D060145-A

PLEASE NOTE D050444 IS SHOWN.
FOLLOW INSTRUCTIONS ON REPLACEMENT
SHEET FOR D050444.

UNLESS OTHERWISE SPECIFIED DIMENSIONS ARE IN INCHES		DATE	NAME	PARTS LIST	
DRAWN	2-16-06	KEM	LIGO CALIFORNIA INSTITUTE OF TECHNOLOGY MASSACHUSETTS INSTITUTE OF TECHNOLOGY		
CHECKED			SYSTEM	LHD /LLO	
			SUB-SYSTEM	TCS	
			NEXT ASSY	NONE	
			PART NAME	QUAD SUS FIXTURE ASSEMBLY	
			SIZE	DWG. NO.	REV
			D	D060145-A	
			SCALE:	SHEET 1 OF 2

ADD 1/4-20 TAP HOLES TO EXISTING PLATE AS SHOWN

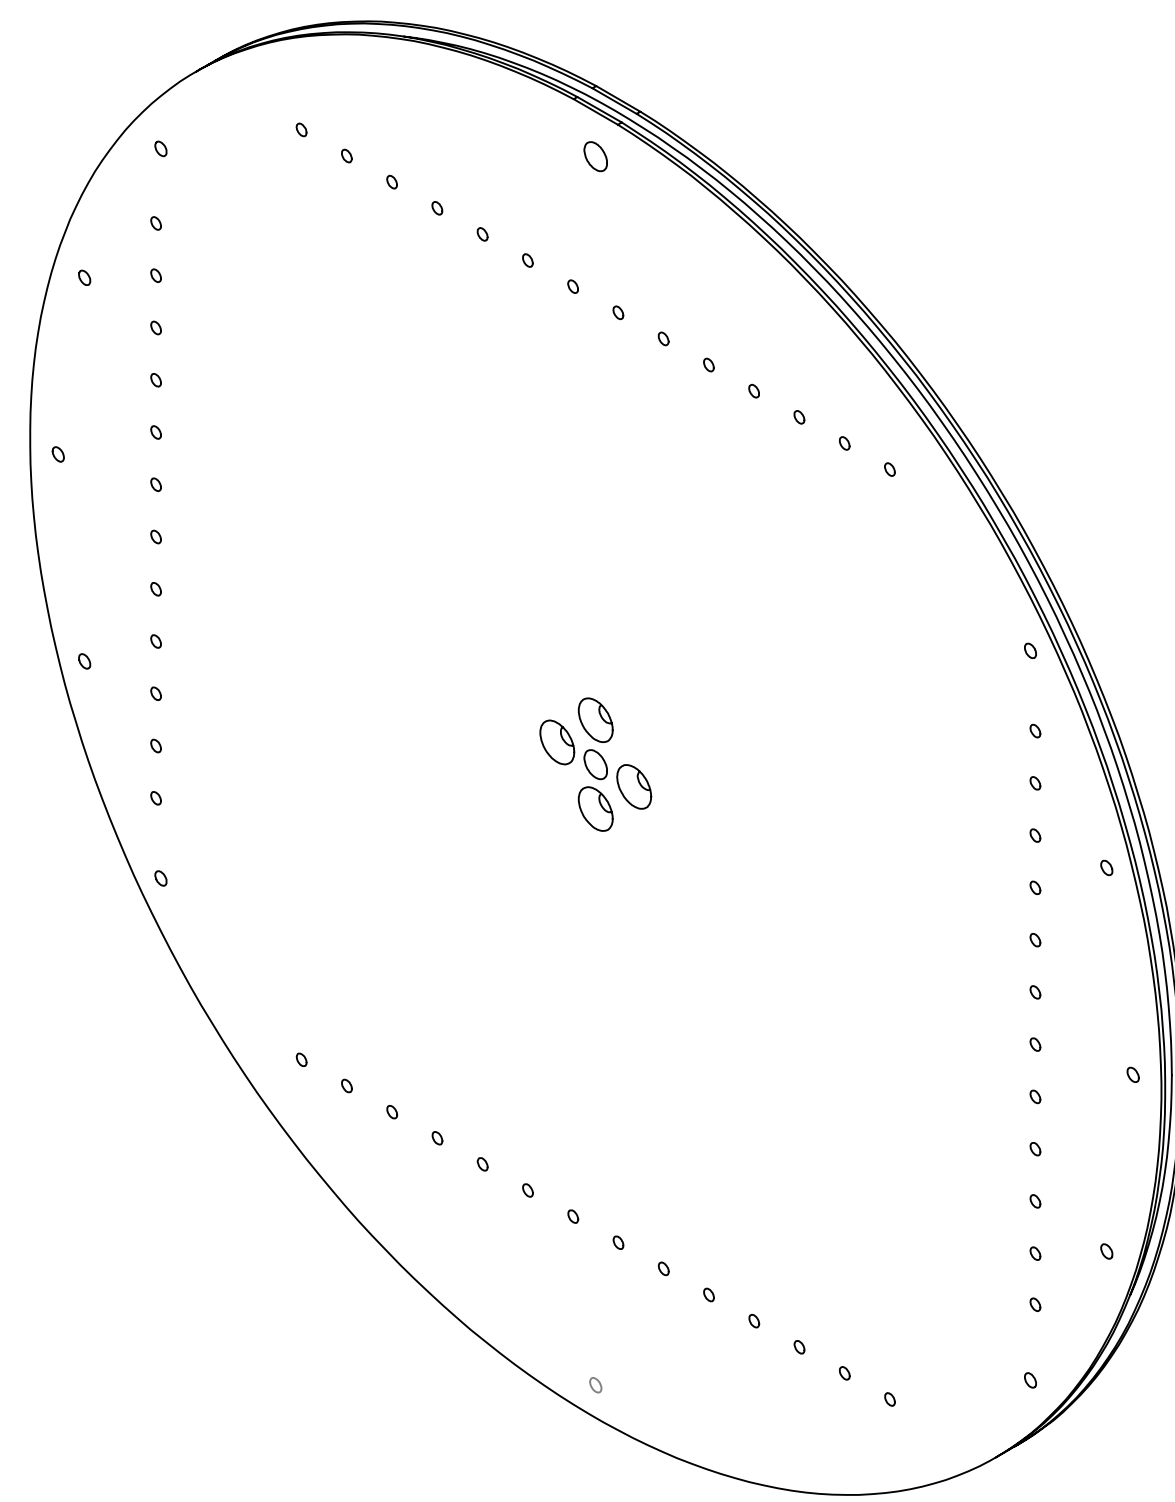
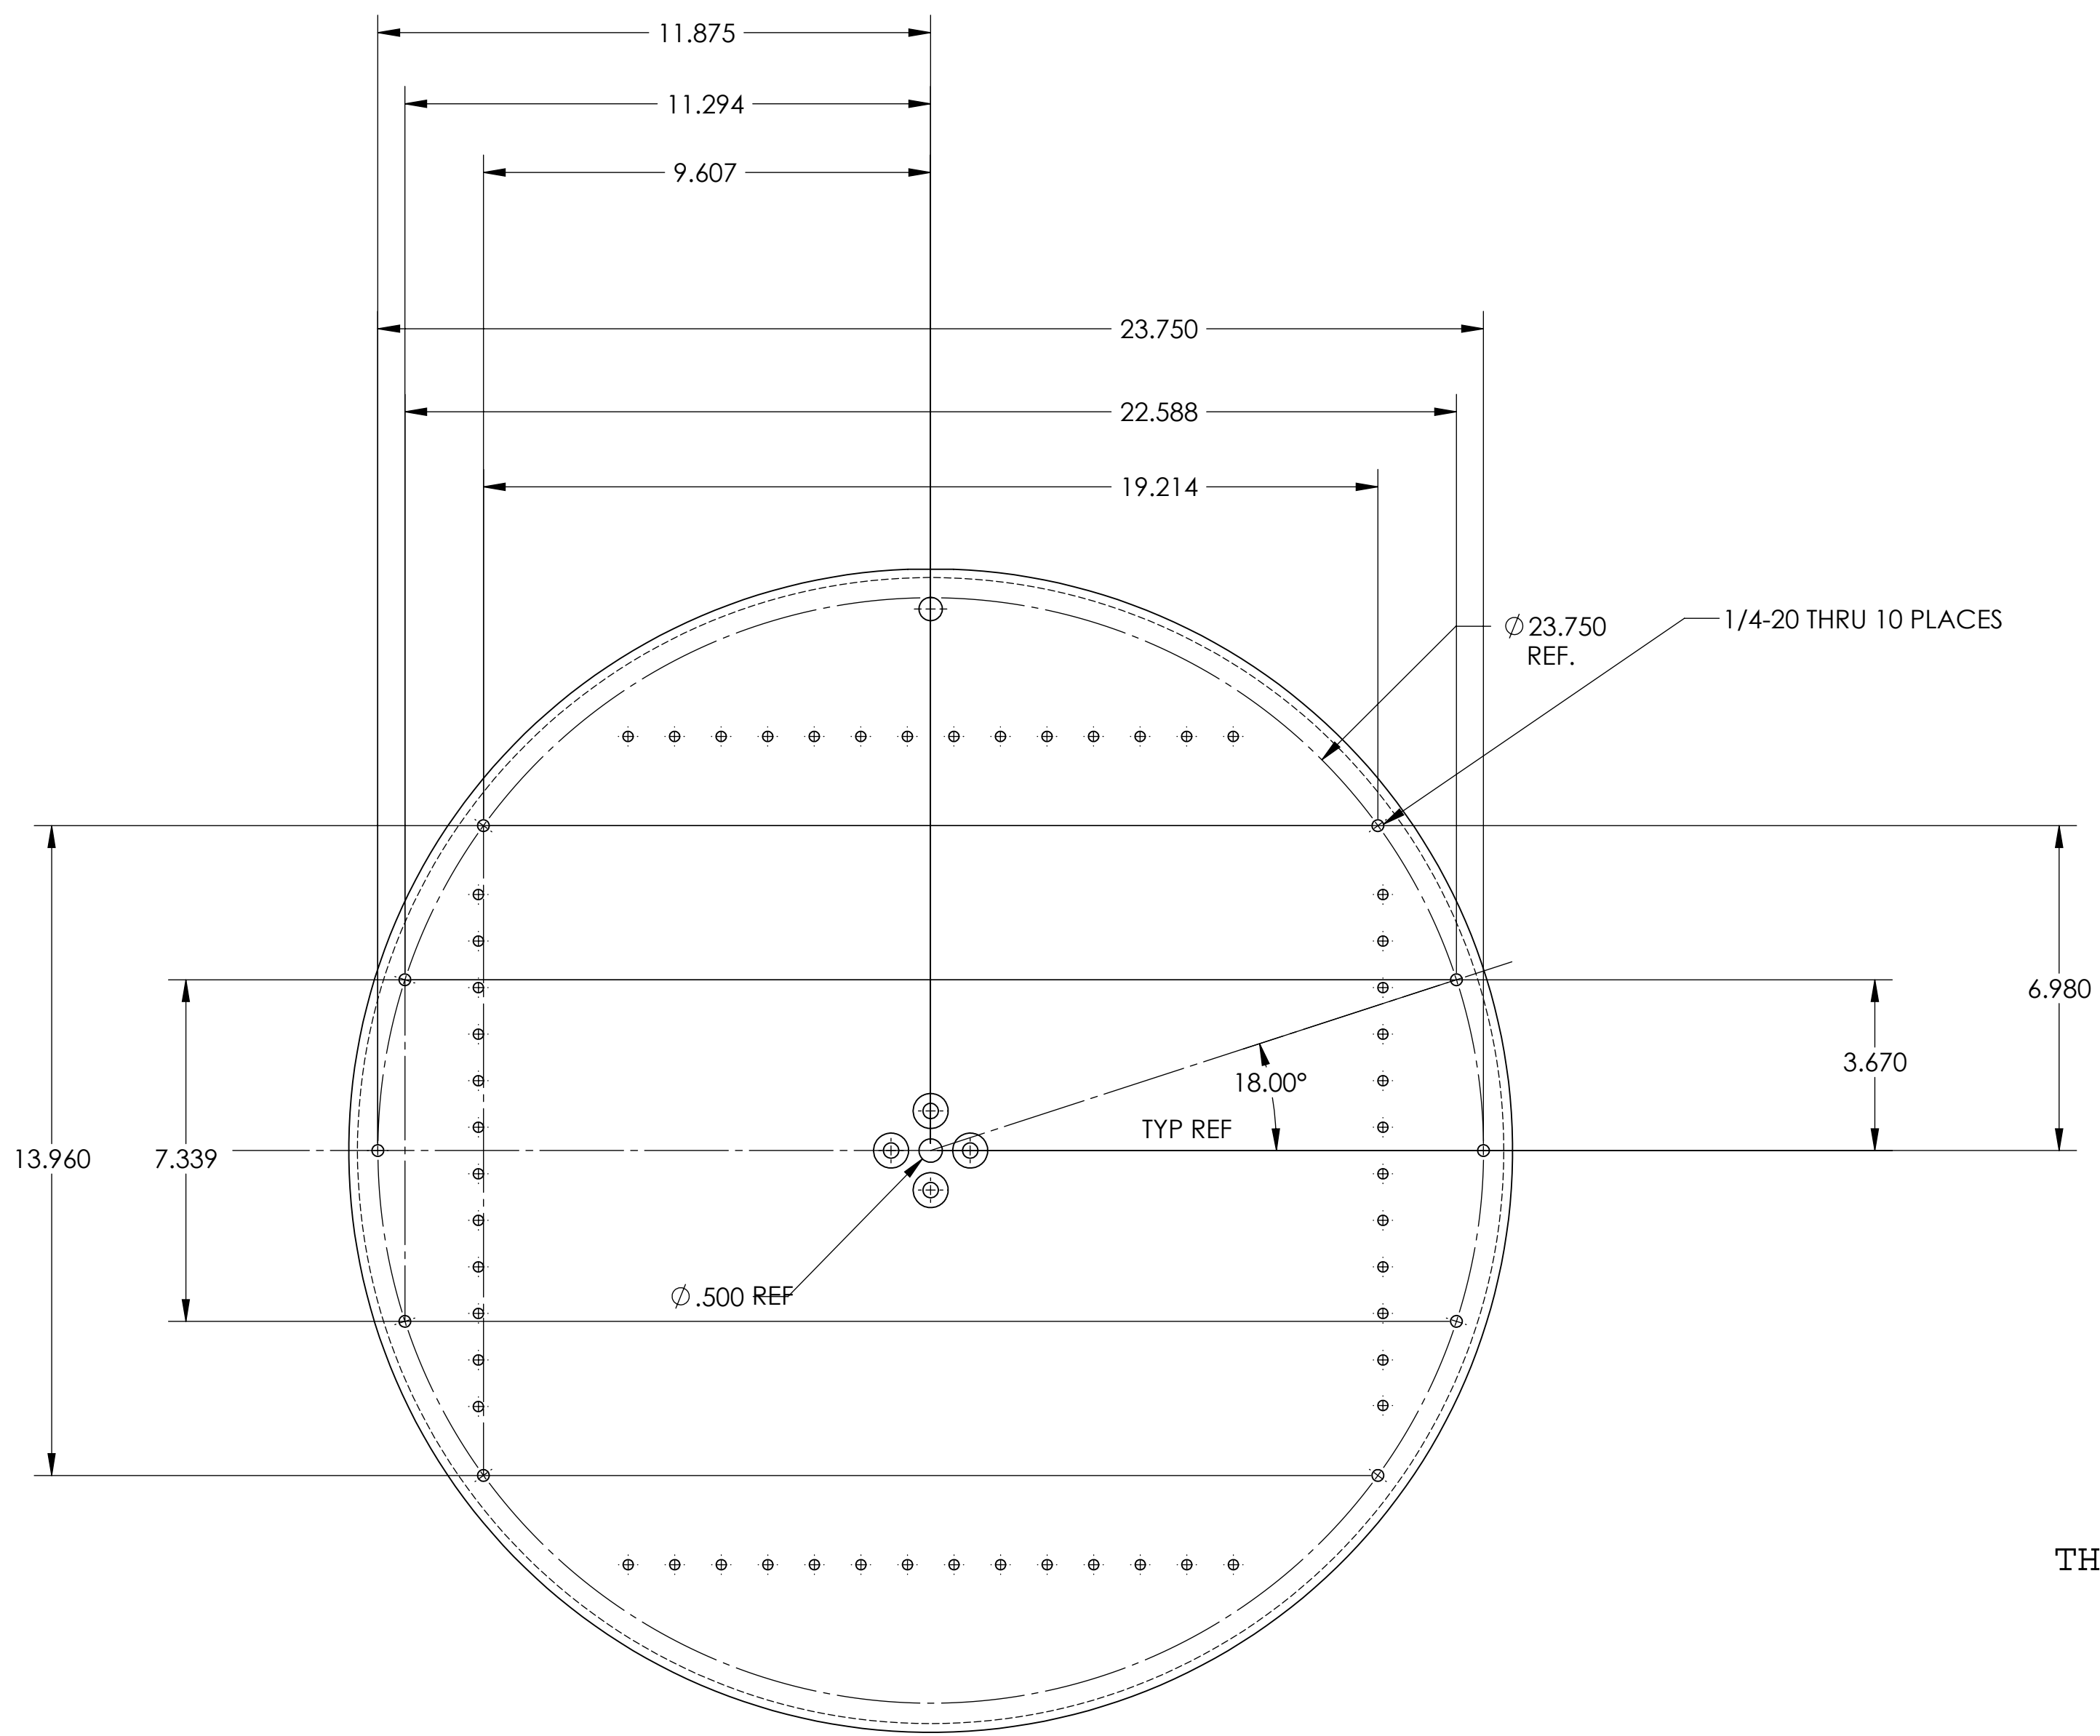
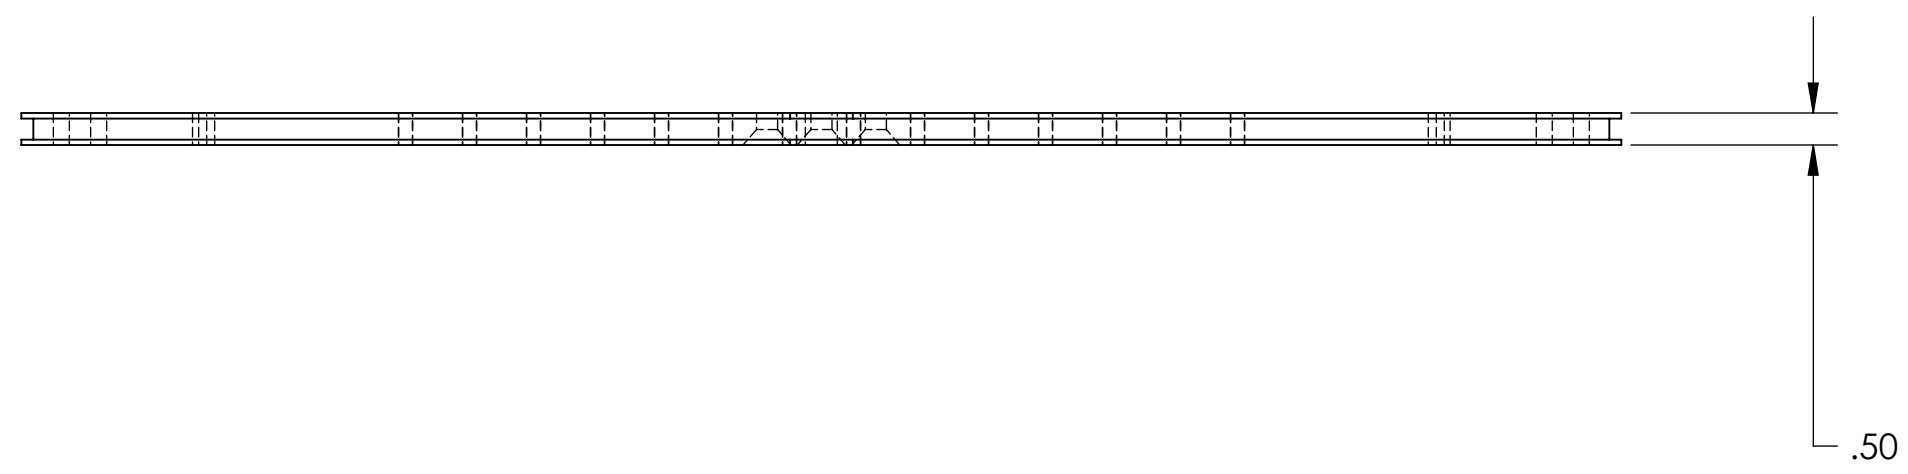
THIS IS A MODIFICATION TO D050450-A AND SHOULD BE INLCUDED AS PART OF THE QUOTE.

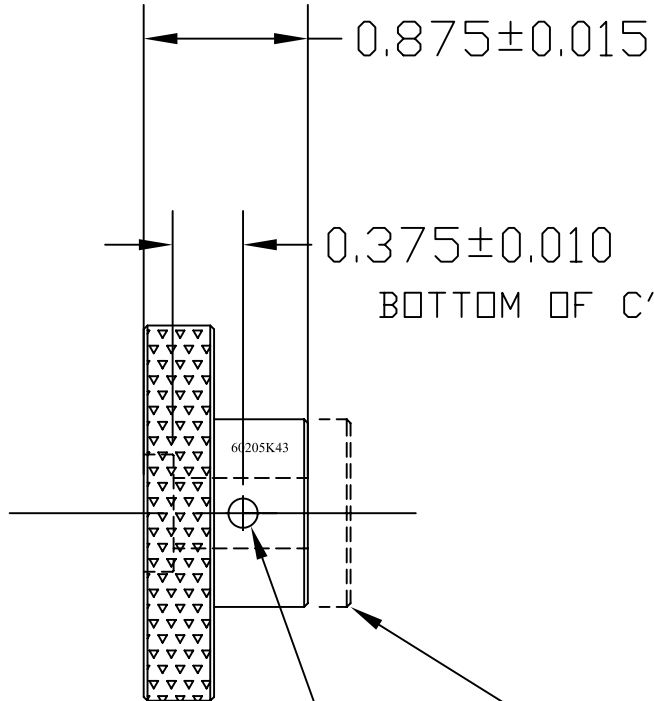
DRILL AND REAM LPF FOR
~~.156 DIA ROLL PIN THRU~~
BOTH WALLS INLINE

drill thru #20 [.161 dia]
not LPF for .156

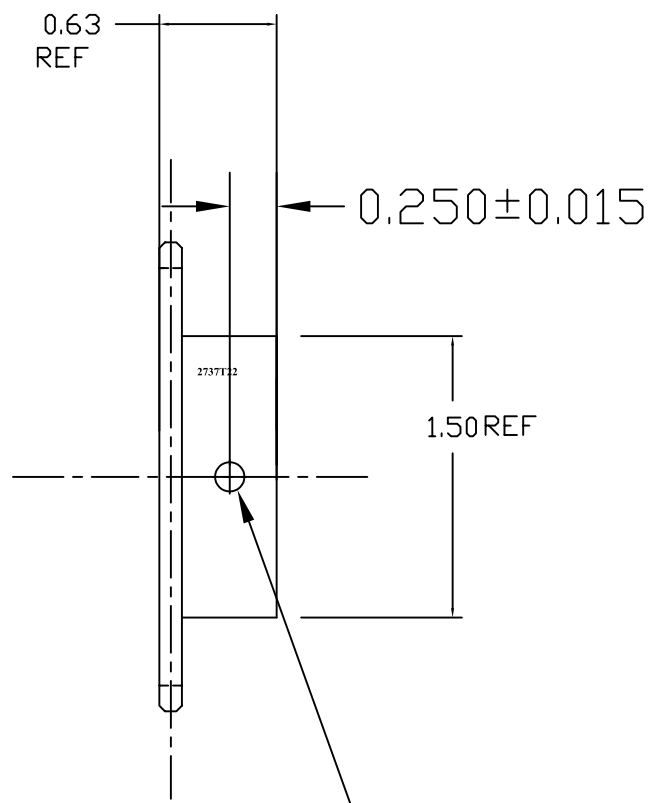
DRILL AND REAM LPF FOR
~~.156 DIA ROLL THRU BOTH~~
WALLS

[center in one of the
existing set screw holes]

drill #20 [.161 dia]
not LPF .156

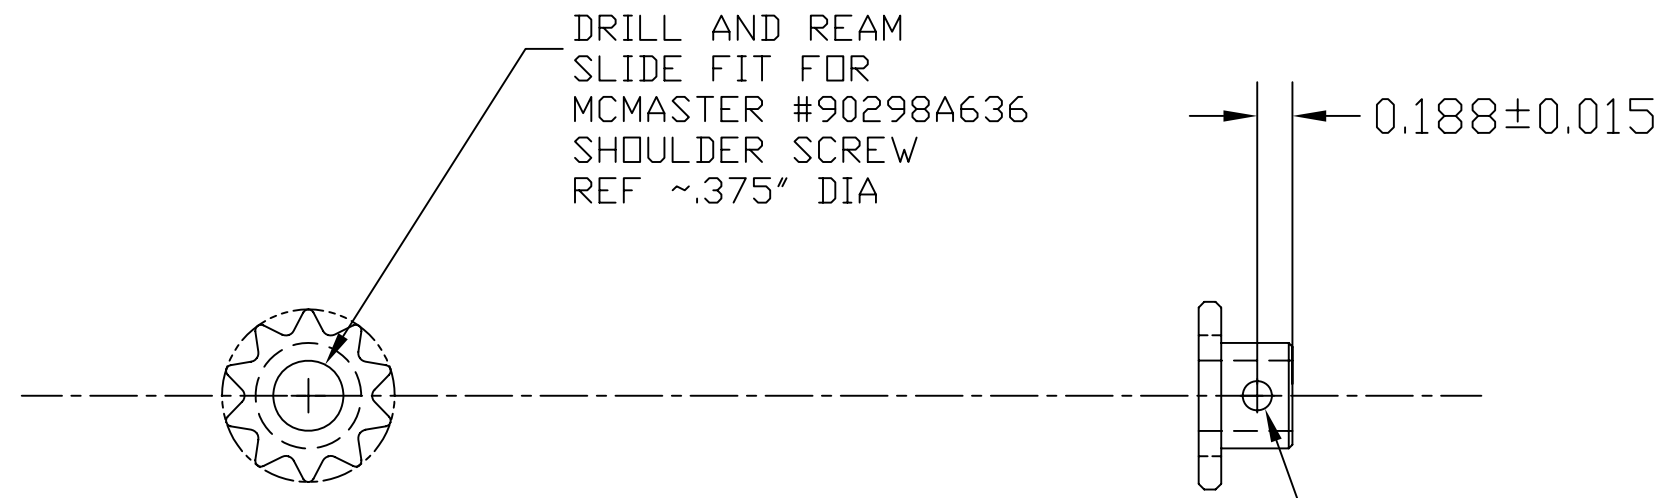
MATCH DRILL AND REAM
~~LPF FOR .156~~ DIA ROLL PIN
THRU ALL [center in
existing set screw hole]
see assembly for
adjacent part

drill thru #20 [.161 dia]
not LPF .15 CIT

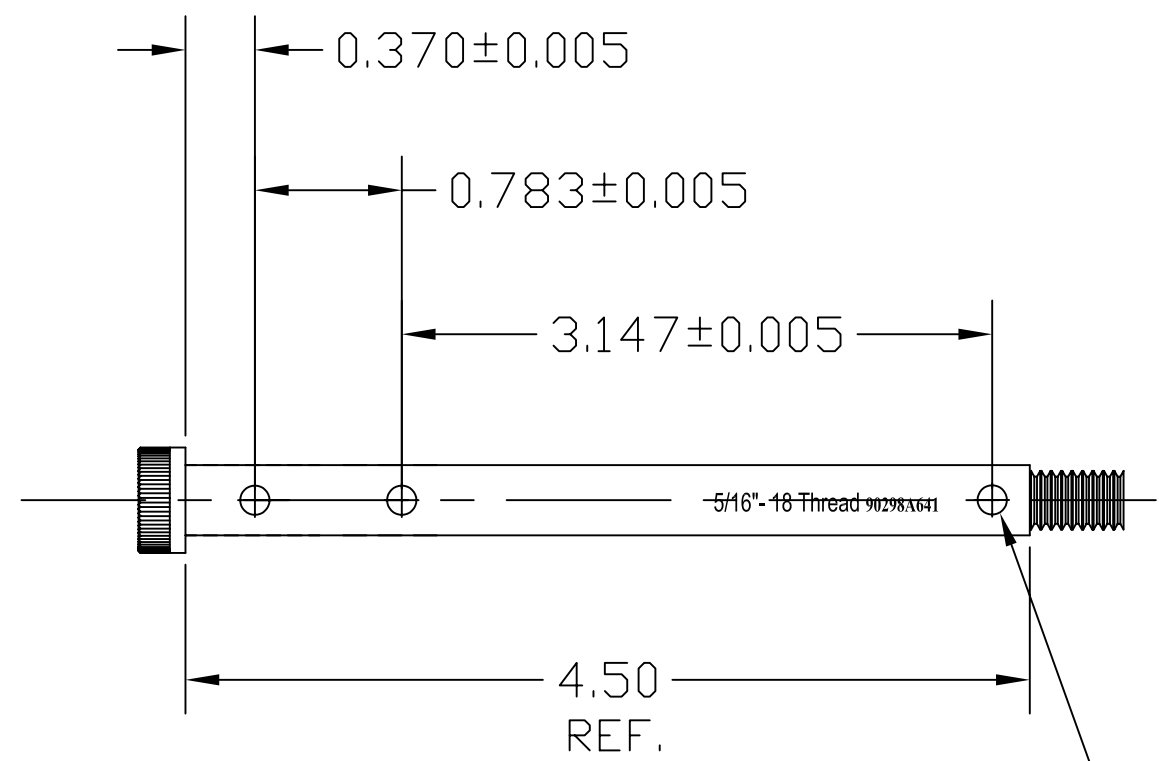
DRILL AND REAM LPF FOR .156 DIA
ROLL PIN THRU 3 PL.

drill #20 [.161 dia thru]
not LPF .156
